STAFF RECOMMENDATION

215 Mayfair Avenue

October 18, 2017

Application: New construction—addition; Partial demolition
District: Cherokee Park Neighborhood Conservation Zoning Overlay
Council District: 24
Map and Parcel Number: 10312017300
Applicant: Michael Marchetti
Project Lead: Melissa Baldock, melissa.baldock@nashville.gov

Figures 3 & 4 show the existing windows that are to be removed on the right elevation.

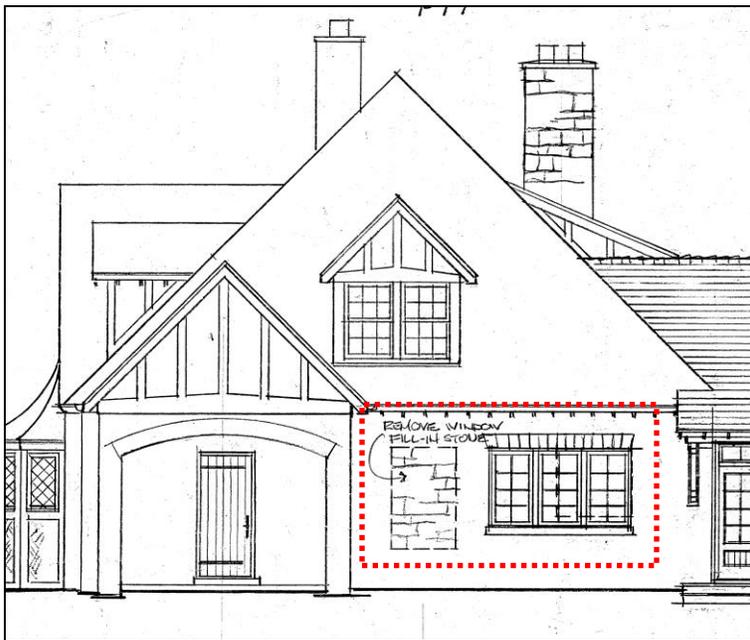
On the right façade, the applicant is seeking to remove both window openings and to create a new window opening (Figures 3, 4, 5).

Staff is not supportive of altering the window openings on the side facades as they are character defining features of the building. Cutting the existing stone for new openings and patching the stone to remove existing openings will have a detrimental affect on the historic character of the house. It is difficult to cut stone without creating a scar, and it is also hard to find appropriate stone to fill in the existing window opening. Although the windows are not highly visible, the fact that the house is stone ensures that the alteration of the window openings will negatively affect the house's historic character.

Staff finds that the alteration of the window openings does not meet Section III.B.2 for appropriate demolition. Staff therefore recommends that the windows on the side façade remain as they are and not be altered.

1. The window openings on the historic stone house remain unaltered;
2. The addition be inset one foot (1') from each the back corners of the house;
3. Staff approve a stone sample;
4. Staff approve the final details, dimensions and materials of windows and doors prior to purchase and installation;
5. Staff approve the roof color, dimensions and texture;
6. Staff approve the material of the side entry stair;
7. Staff approve the floor and stair material of the rear porch;
8. Staff approve the driveway material; and
9. The HVAC shall be located behind the house or on either side, beyond the mid-point of the house.

Figure 8. The addition's right elevation shows its depth relative to the historic house. Because of the addition's depth, staff recommends that it be inset 1' from the back corners of the historic house.

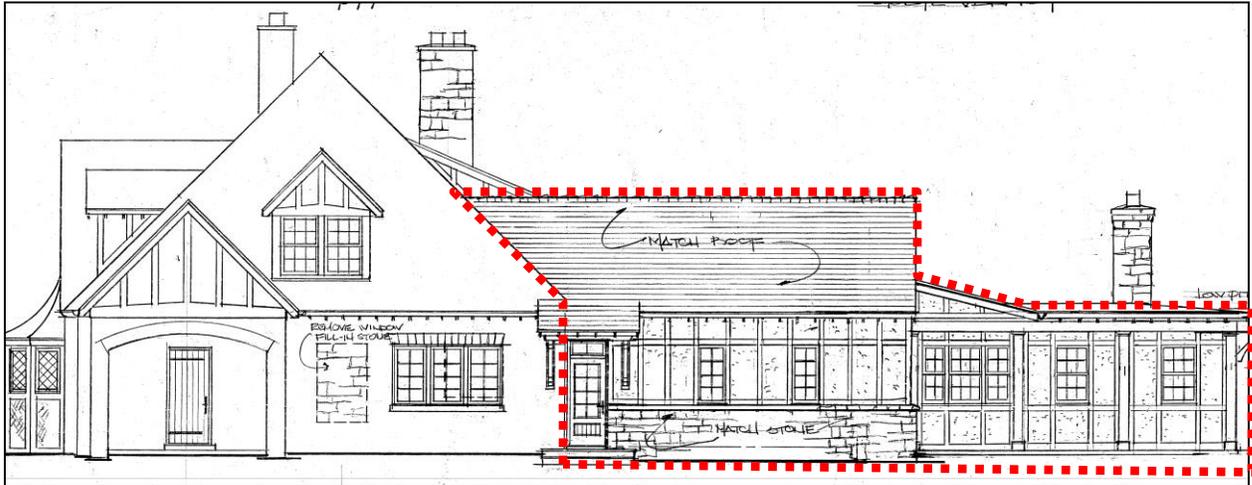
is a change in materials, as the house is stone, and the new addition will be stucco board-and-batten; however, the addition's depth is large. On the right side, its total depth is nearly fifty feet (50'), and is deeper than the historic house (Figure 8). On the left side, its depth is over thirty-three feet (33'). Because of the size of the addition's footprint, staff recommends that the addition be inset a minimum of one foot (1') from each of the back corners of the house.

The addition is large in footprint, and approximately doubles the footprint of the house. Because the addition is one story and significantly shorter in height, staff finds that the addition's footprint is appropriate, if it is inset one foot (1') from both of the back corners.

With the condition that the addition be inset one foot (1') on both sides, staff finds that the project meet Section II.B.1.a., II.B.1.b., and II.B.2. of the design guidelines.

10/9/17
LEFT SIDE ELEVATION
ZOETZ-VARNEY

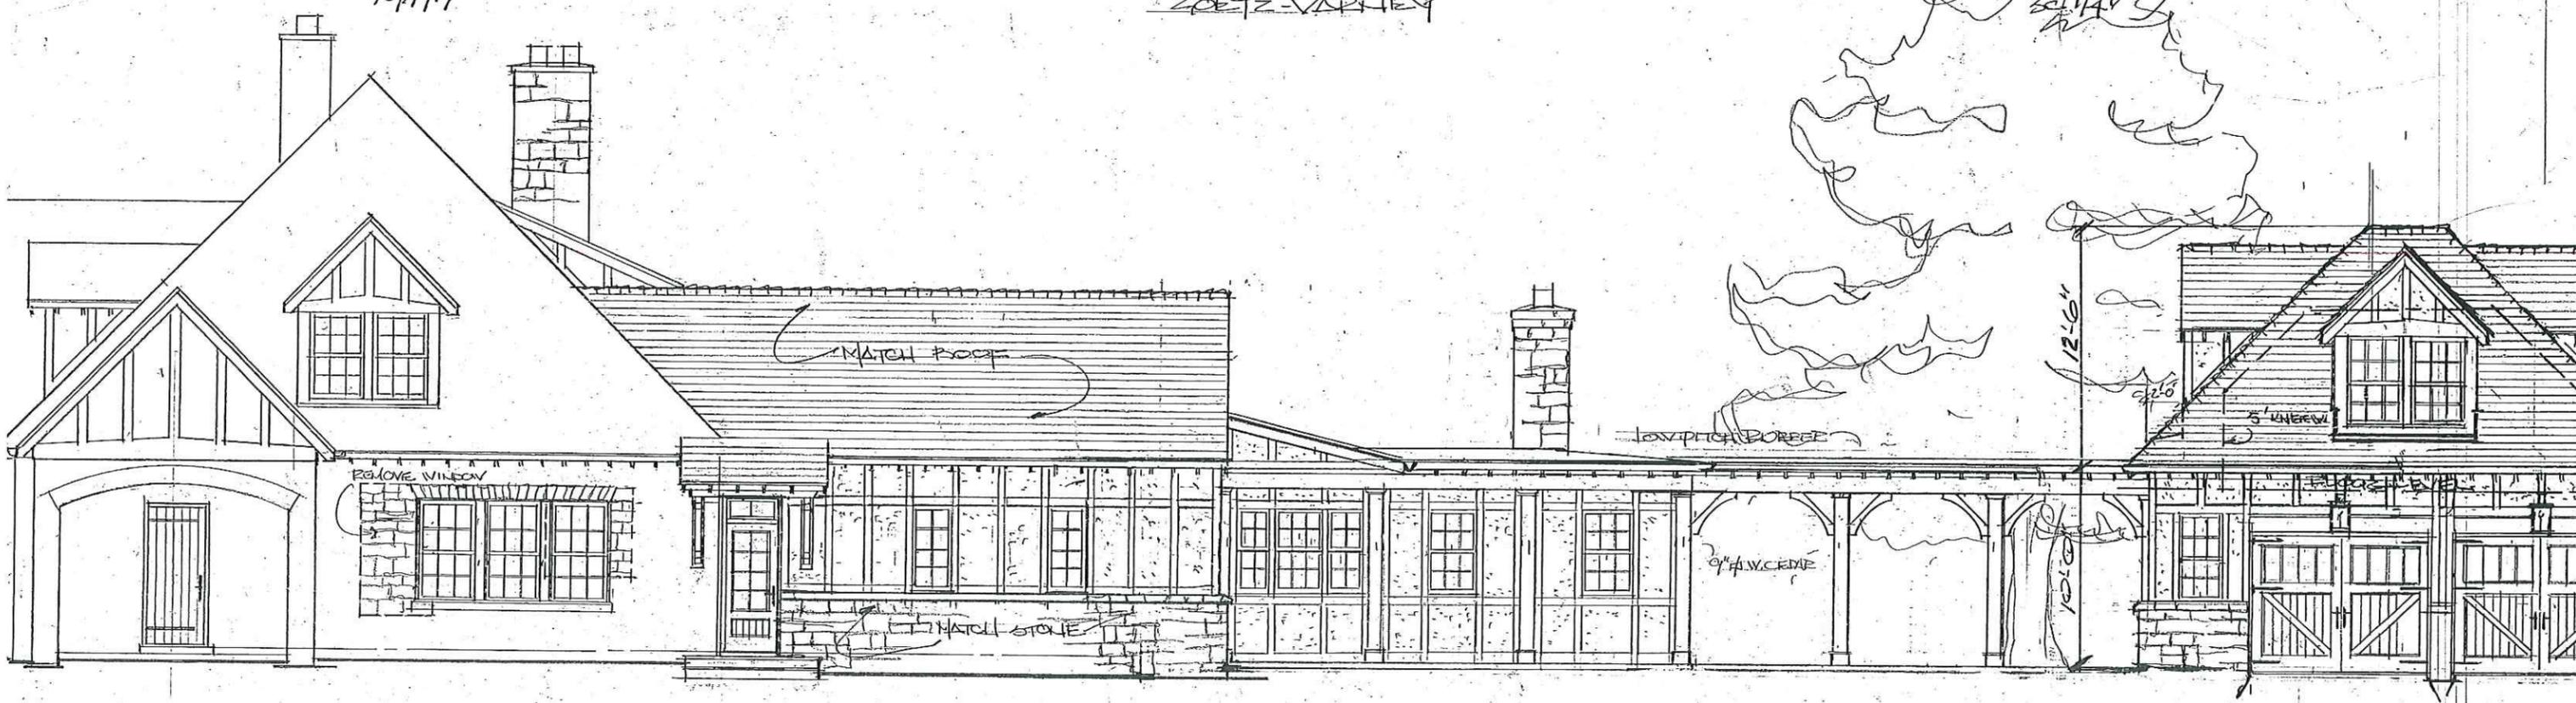
On the left elevation, one of the existing windows will remain, but the applicant is proposing to insert two new window openings in between the existing window openings (Figures 6 & 7).
